Cencon Generation II Lock Cencon/CenTran 4 Software

Generation II Lock

What is the Cencon Generation II (Gen2) lock?

Figure 2

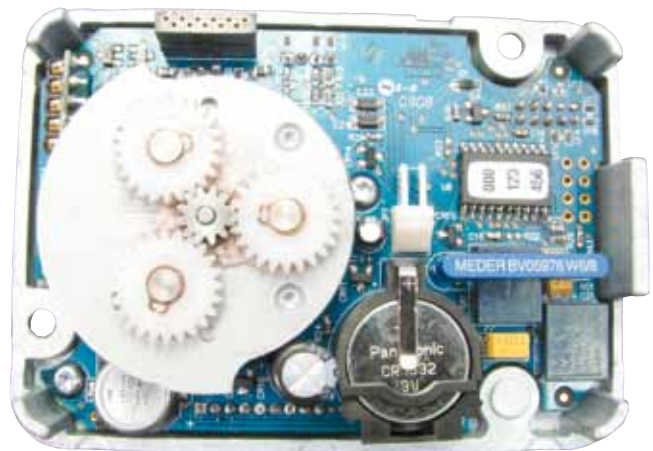
Electronic card: Gen2 has a coin-cell battery and a black battery retainer for running the on-board clock, and the serial number sticker showing 3 sets of 3 numbers. (Figure 2.)
